Data Request #	Section/ Page	Section	Topic	Information Request	Applicant Response
Veg-4	Part 4.8; Attachment L	Vegetation	Revegetation	Provide information clarifying how revegetation will lead to restoration. Within the WDFW Wind Power Guidelines, temporary impacts to habitats are those that are restored following construction. Within the definition “the goal of restoration of temporary impacts should be to restore habitats to a condition at least as good as its pre-project condition”.	The Vegetation and Weed Management Plan (to be provided in September 2023) will outline the native seed mixes that will be used during revegetation efforts in both grassland and shrubsteppe communities. Attempts to minimize temporary disturbance will be made, particularly temporary disturbance to shrubsteppe communities, which take longer to reestablish during revegetation. Revegetation of grasslands will be completed by the end of the growing season that follows the completion of construction. This will allow for reseeding during post-construction and ample time for the site to receive adequate rainfall, which is a limiting factor for revegetation in Eastern Washington. Shrubsteppe communities will

Field Verified Habitat and NLCD Land Cover

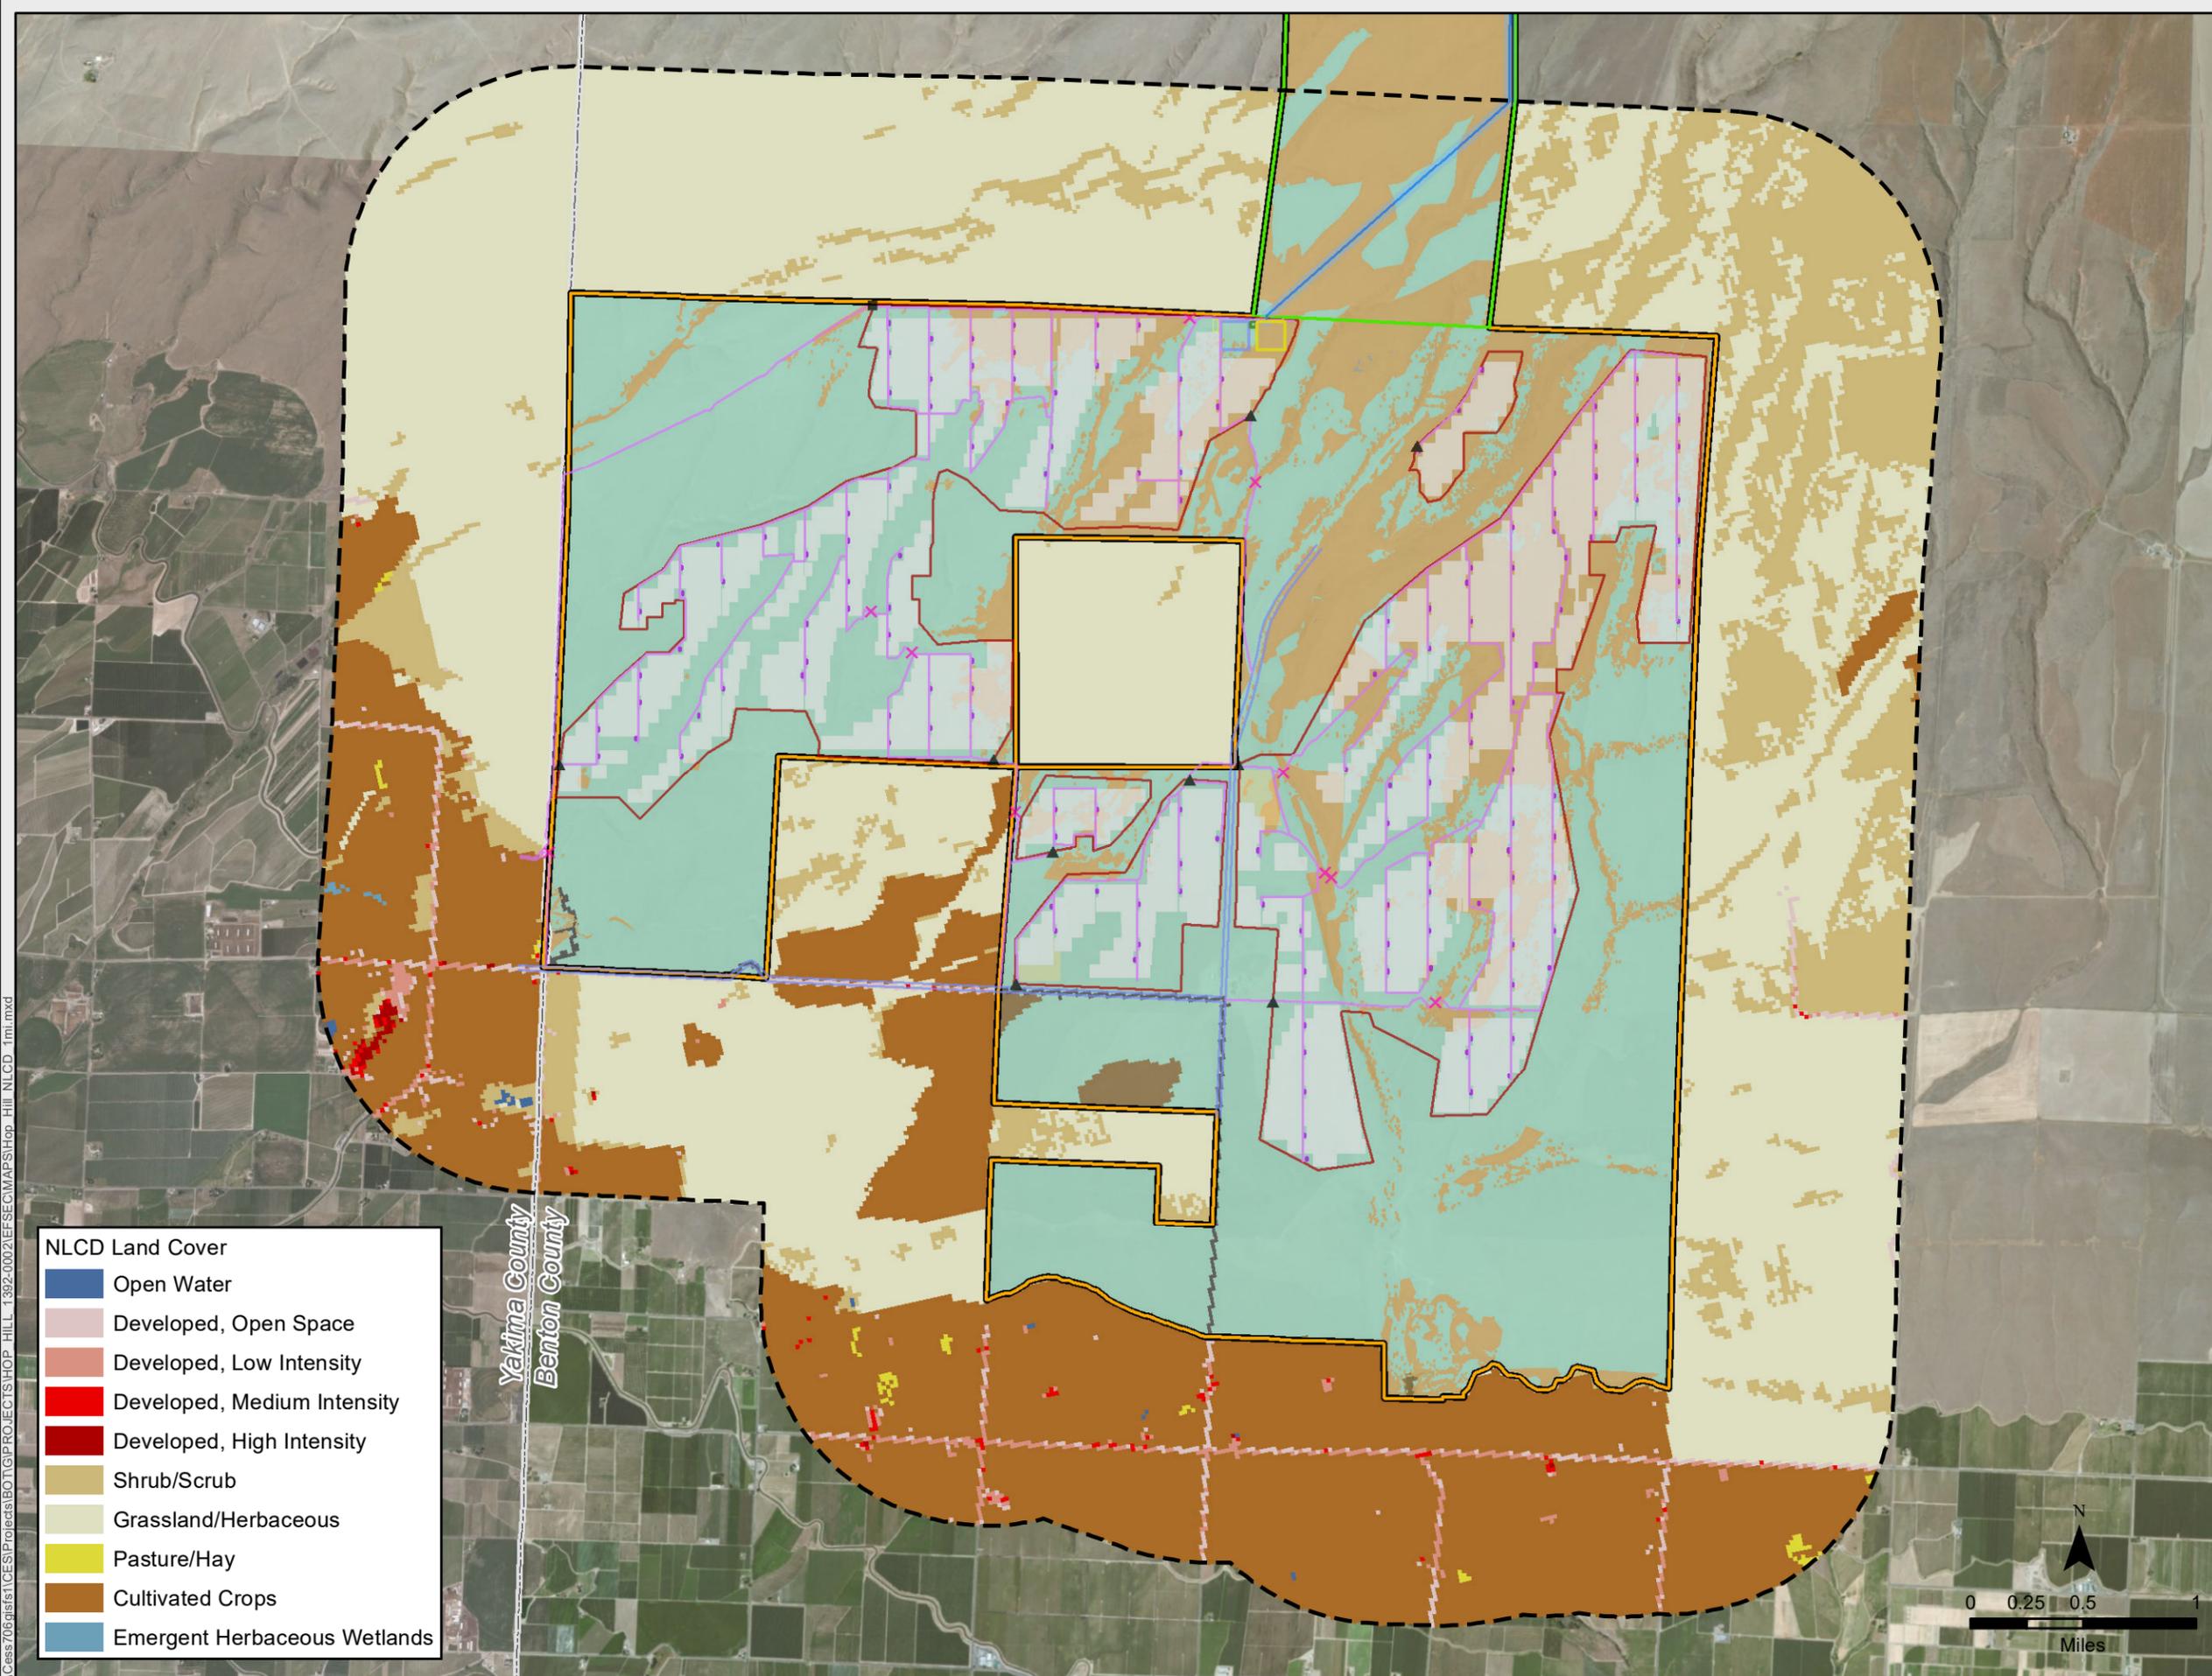
Veg-5	Part 3.8; Part 4.8; Attachment E	Vegetation	Field surveys were constrained to the Project Siting Area; however, the exact extent of the area reviewed during the surveys is not provided in the ASC. The ASC submittal does not include surveys for special status plants or noxious weeds. The absence of surveys for special status plants and noxious weeds limits the ability to evaluate all Project impacts on special status plants and noxious weeds.	Provide local extent of priority habitat adjacent to the Project Siting Area to provide spatial context to the impacts of priority habitats within the Project Siting Area.	See Attachment Veg-5 .
Veg-6	Part 4.8	Vegetation	Vegetation and Weed Management Plan	Provide a draft Vegetation and Weed Management Plan that can be reviewed in consultation with EFSEC, the Benton County Noxious Weed Control Board, and WDFW. The revegetation plan should include specific revegetation and restoration measures that support the classification of impacts as “temporary” and “altered”.	A draft Vegetation and Weed Management Plan will be completed and submitted to EFSEC in September 2023.

Veg-5: Provide local extent of priority habitat adjacent to the Project Siting Area to provide spatial context to the impacts of priority habitats within the Project Siting Area.

In order to address the question regarding the local extent of Priority Habitat types adjacent to the Project Siting Area a summary of habitat types within one mile of the Solar Array Siting Area has been provided (Figure to Attachment Veg-5). Field surveys were not conducted within one mile of the Solar Array Siting Area so desktop data from the National Land Cover Dataset was used instead. Field verification of habitat types was conducted inside the Solar Array Siting Area so more detailed habitat mapping has been completed and previously provided. Because of that, field verification and similarities between habitat types and land use inside and outside of the Solar Array Siting Area, some assumptions were made regarding habitat types outside of the Solar Array Siting Area regarding habitat classification. Land cover types in the NLCD was cross-walked into the Washington Department of Fish and Wildlife habitat classifications in the 2009 Wind Power Guidelines (Table 1). The main implication of that is that the areas shown as Herbaceous on Attachment Veg-5 have been recategorized as Croplands, Pasture, Urban and Mixed Environs because they are likely heavily grazed rangelands similar to what has been observed in the Solar Array Siting Area.
